**RE: Contract NRC-02-81-026  
Benchmarking of Computer Codes and Licensing Assistance**

**CorSTAR/TTS Project 6280  
Quality Control Review  
September 1, 1987**

**Benchmarking of Computer Codes  
Quality Control Review**

**"Benchmarking of Flow and Transport Codes for Licensing Assistance", May 1987, GeoTrans, Inc.**

Figure 4.15. Schematic drawings of typical grid blocks in Cartesian and curvilinear geometries for use with SWIFT and problem 5.2.

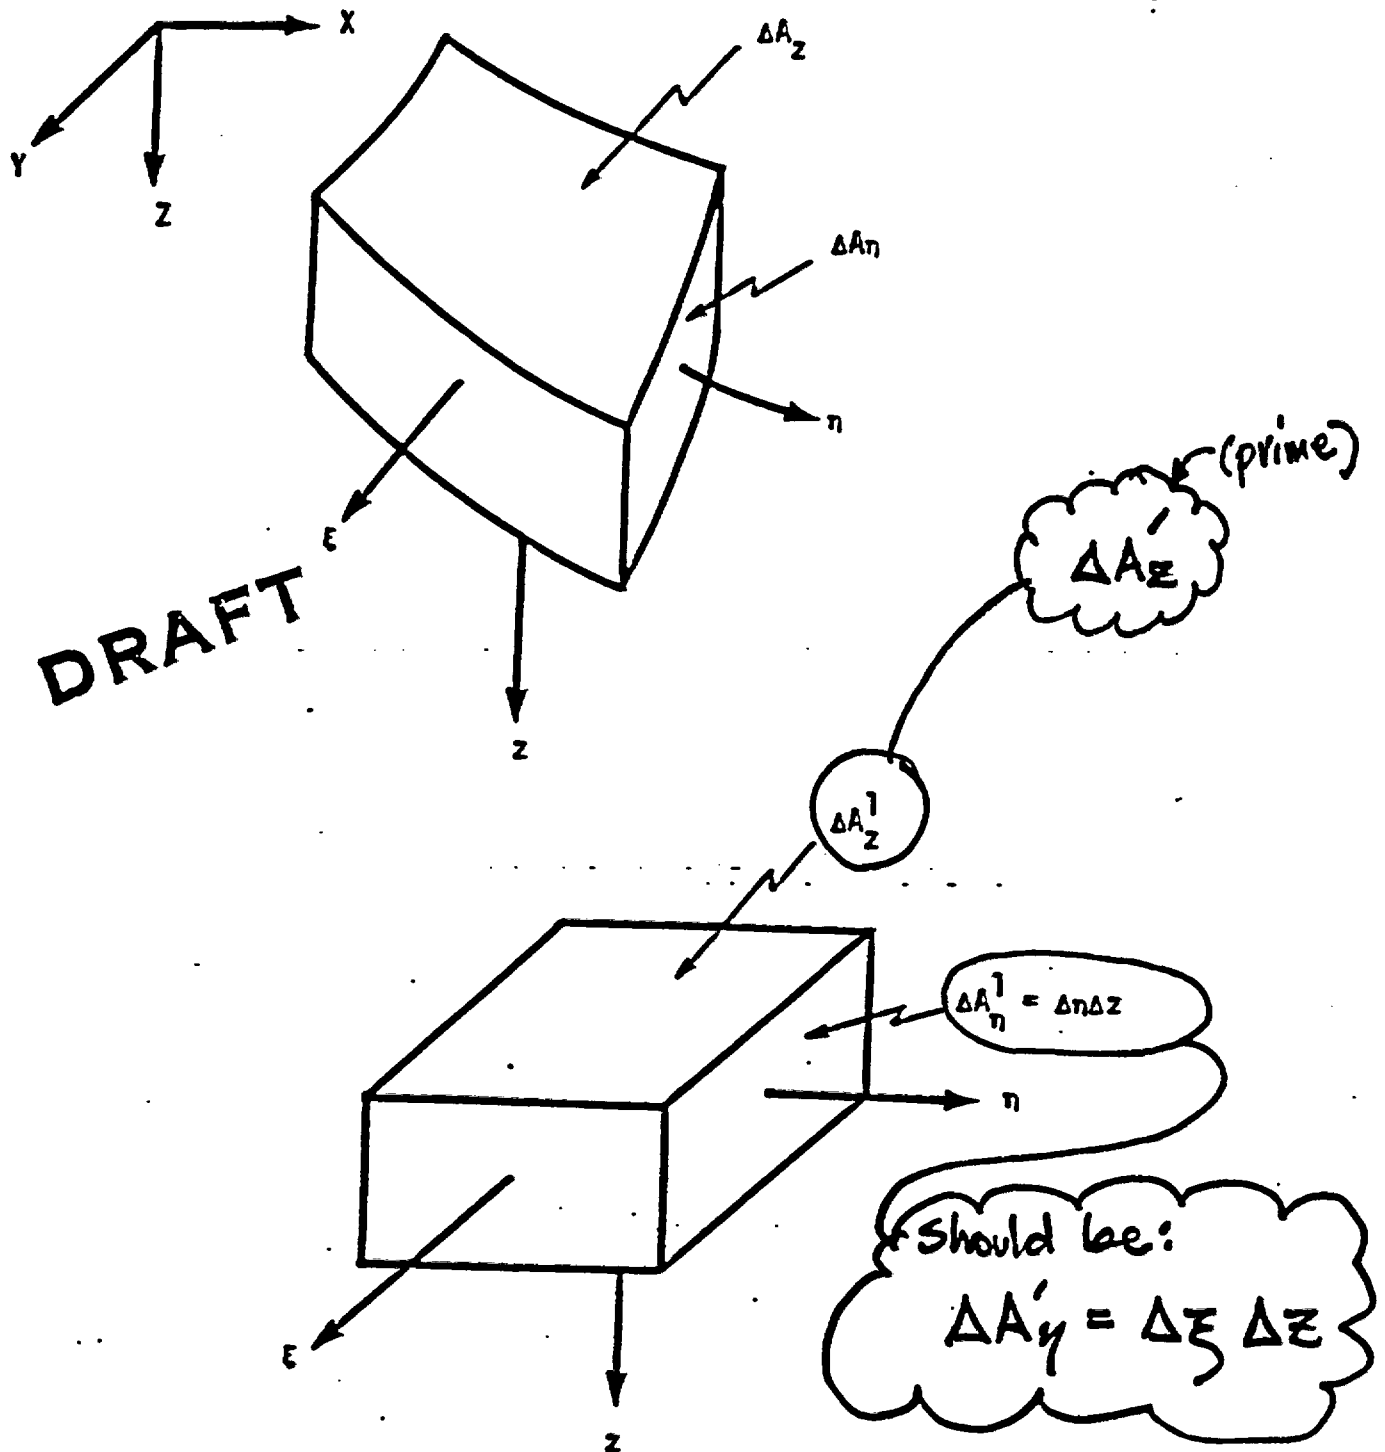
Should be 4.14

Figure 4.30a. Curvilinear coordinate geometry of flow region used in SHIFT for problem 8.2.

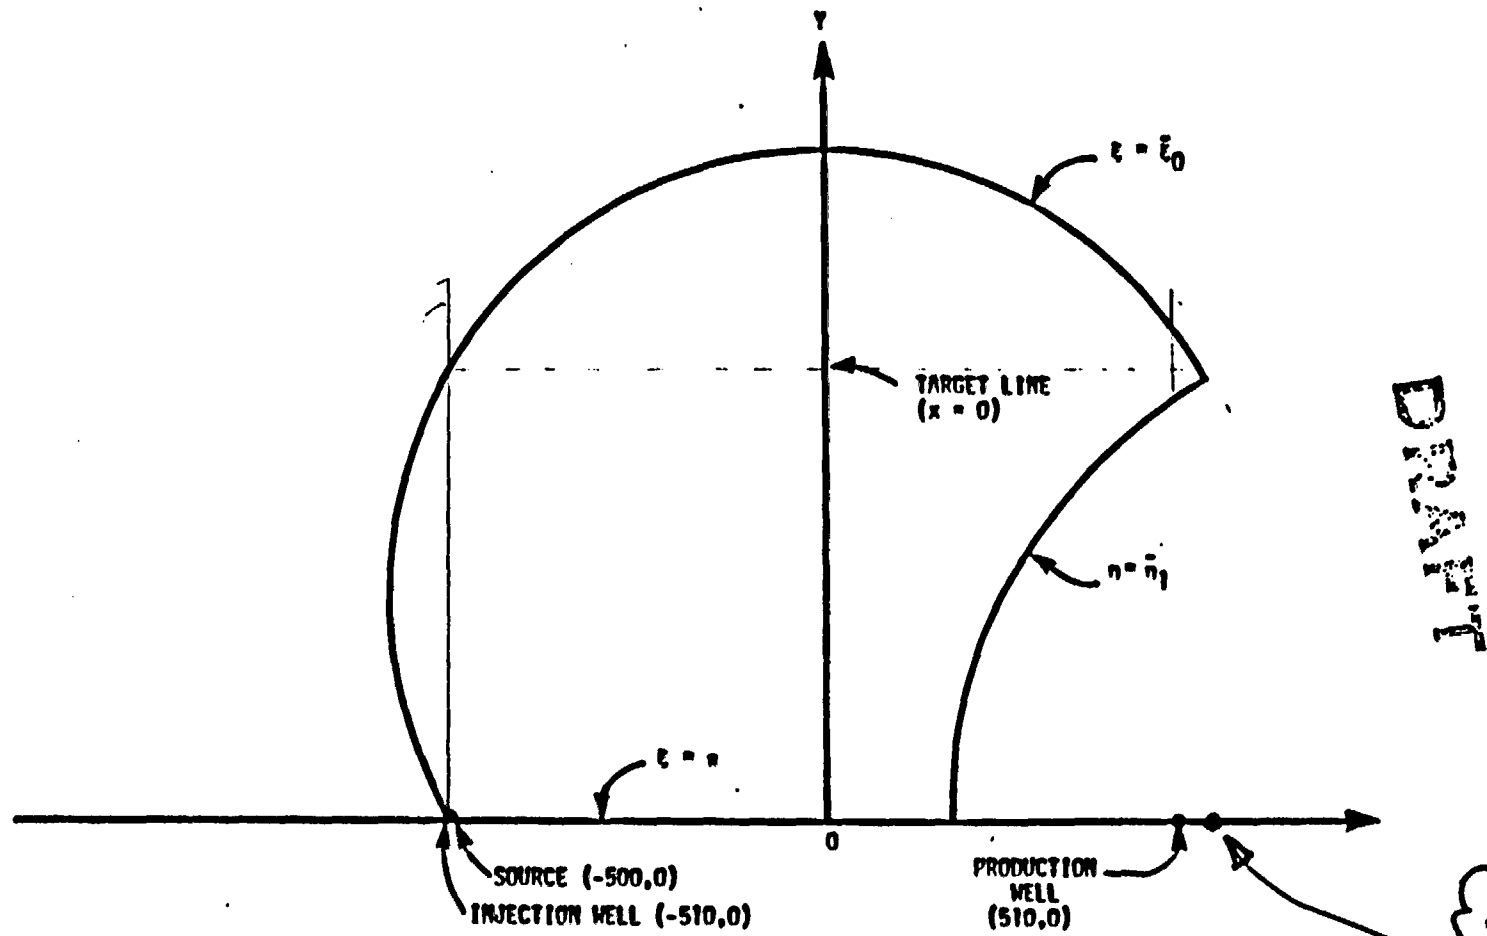
Should this be 4.30b?

Should be  $x = 0$

Figure 4.31. Target-line profiles of  $^{234}\text{U}$  at times of maximum discharge for Cartesian and curvilinear simulations of problem 8.2 using SWIFT.

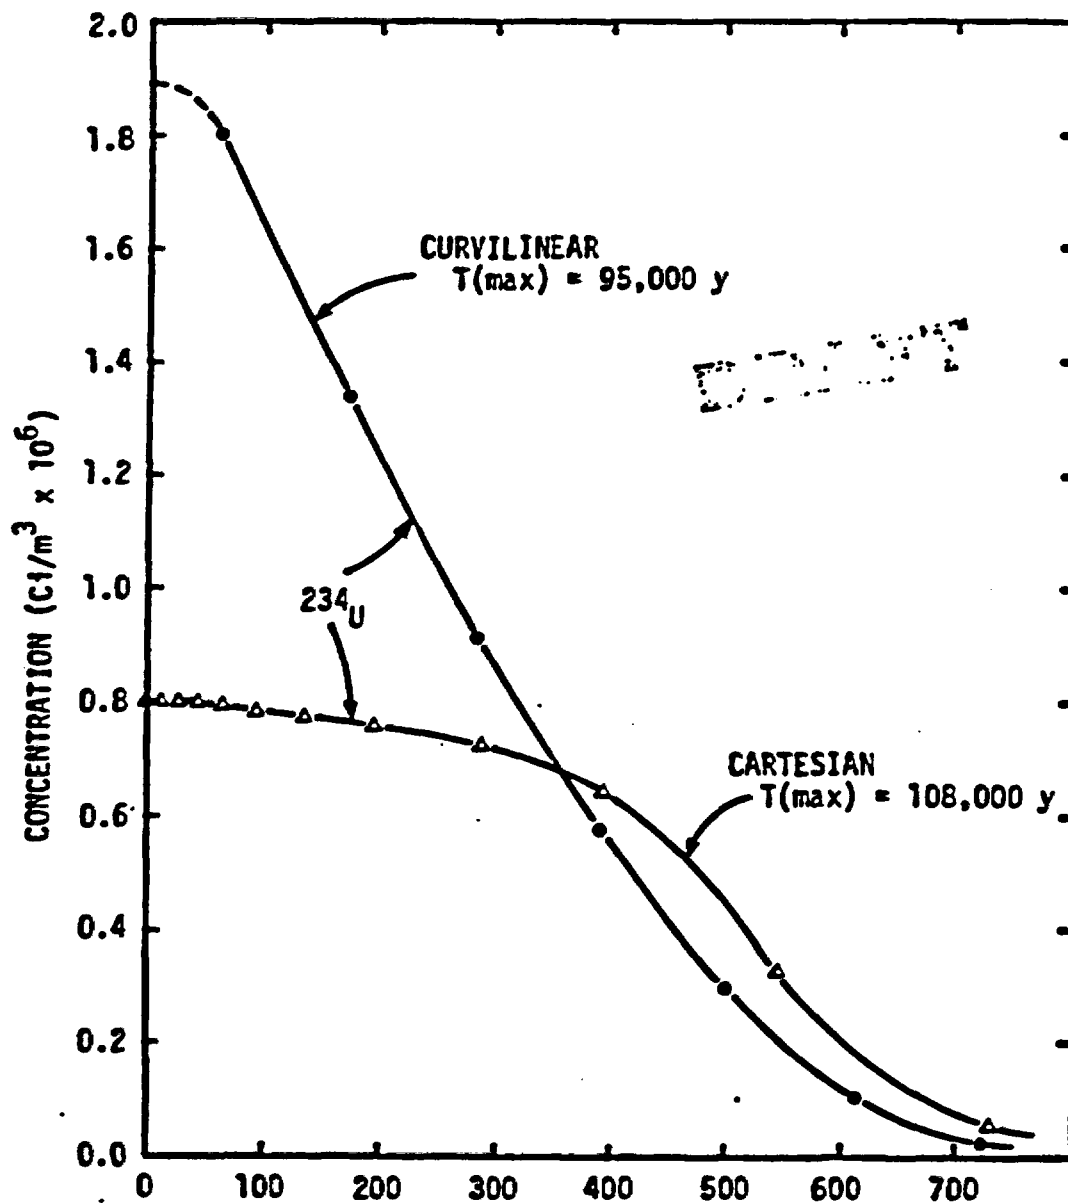
3. For results in the form of release rates across the target line, it should be mentioned that twice the tabular values (Table 4.40), should be used for comparison, since symmetry about the x-axis was employed. Also, reference should be made to comparison of results with other codes e.g. NUTRAN.
